EQUIPMENT UPDATE

Log Number: EU-08-397

Part Description: OPTIONAL DOOR SWITCH SHIELD PN# 00562.70

Models Affected: ALL STRAIGHT THRU MODELS

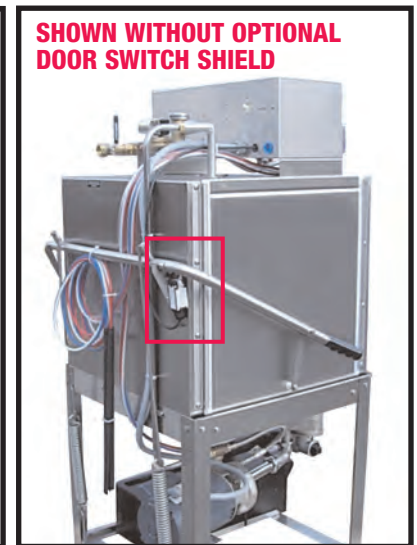
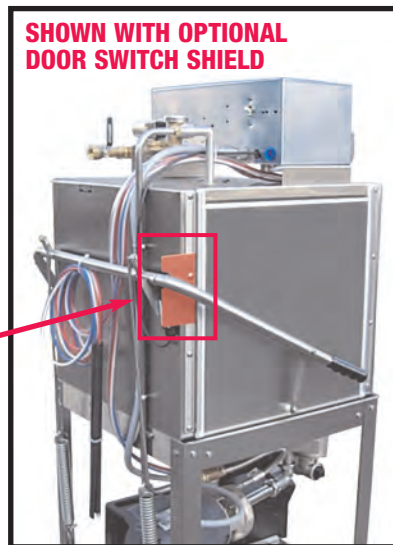
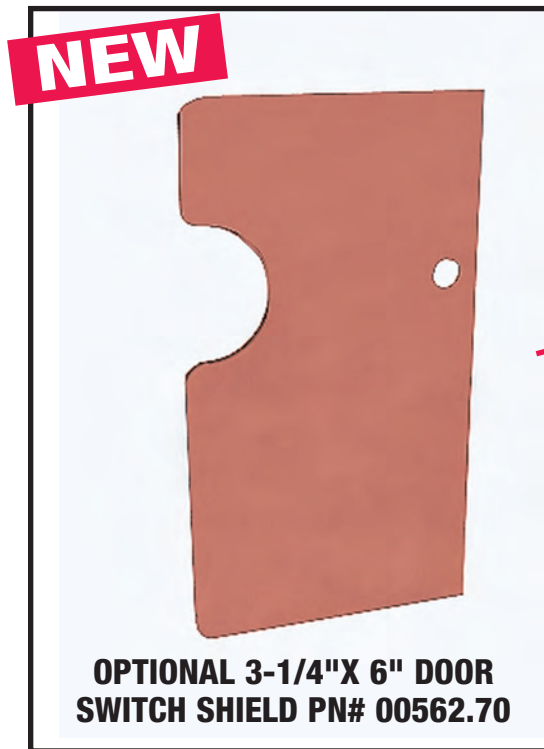
Field reports indicate under certain conditions that the **“Door Safety Switch”** may be subject to water spray from the pre-rinse assembly (when the soil table is located on the left side of the machine).

CMA has created an Optional **Door Switch Shield** to protect and minimize moisture contact with the **Door Safety Switch**. To install: remove existing bolt and nut hardware from door guide and install shield. Replace bolts and nut hardware.
